Facility Improvements-PHI (Site Improvements)

Project: GS 383-001

ADDENDUM NO. 2:

Date of Addendum:
August 30, 2019

Date:	17 JUNE 2019
Scale:	AS SHOWN
Drawn:	SLH
Approved:	WAD
Job:	1804
Sheet:	C132
Of	Sheets

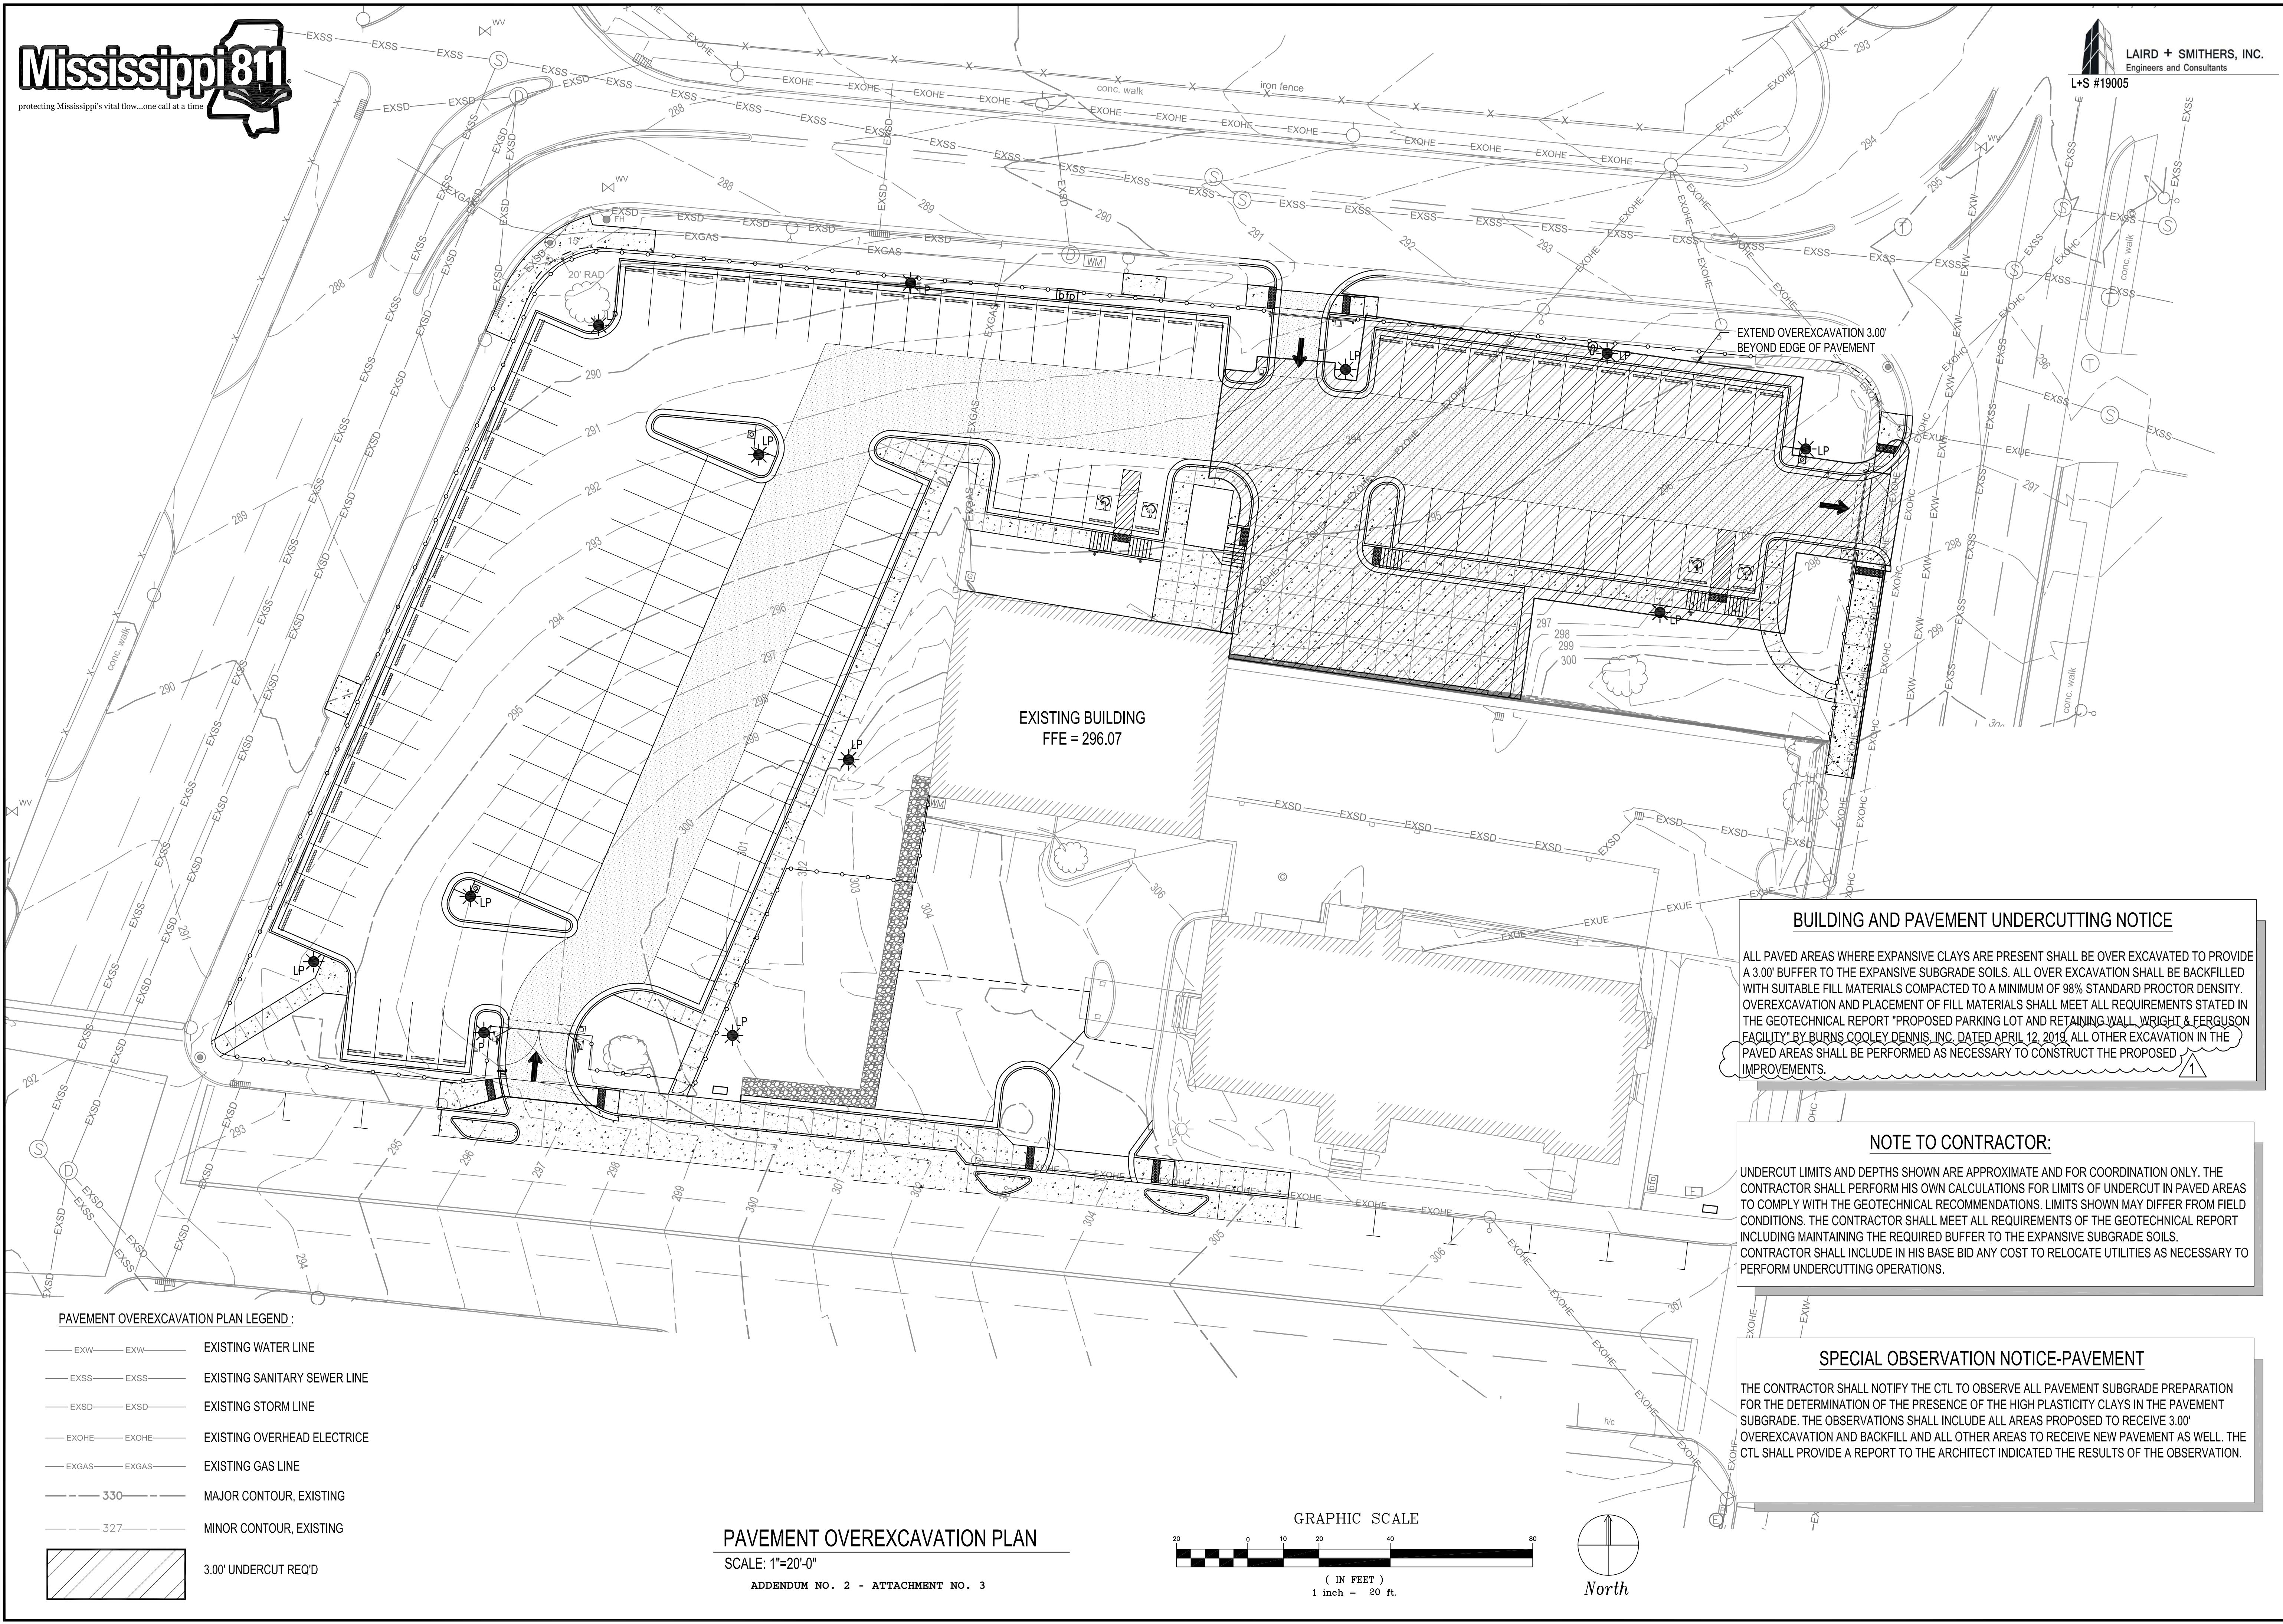
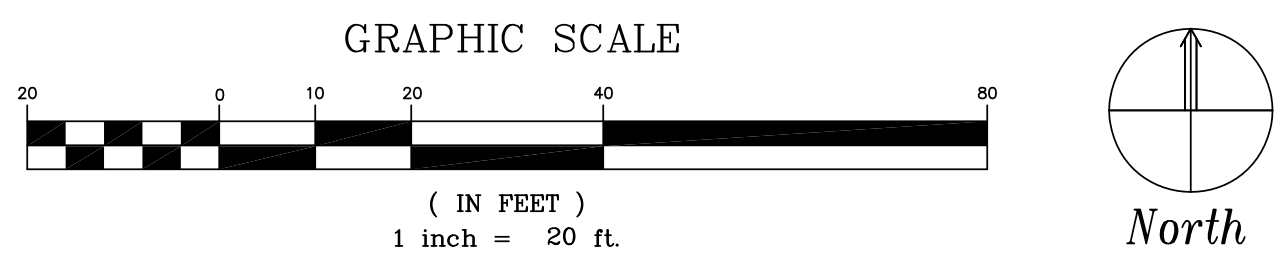
Item No. 2 **Drawings, Sheets C101, C121, C131, C132, C141, C205:**
Replace: Replace Sheets C101, C121, C131, C132, C141, and C205 with Sheets C101, C121, C131, C141, and C205 included at this Addendum as Attachment No. 3.
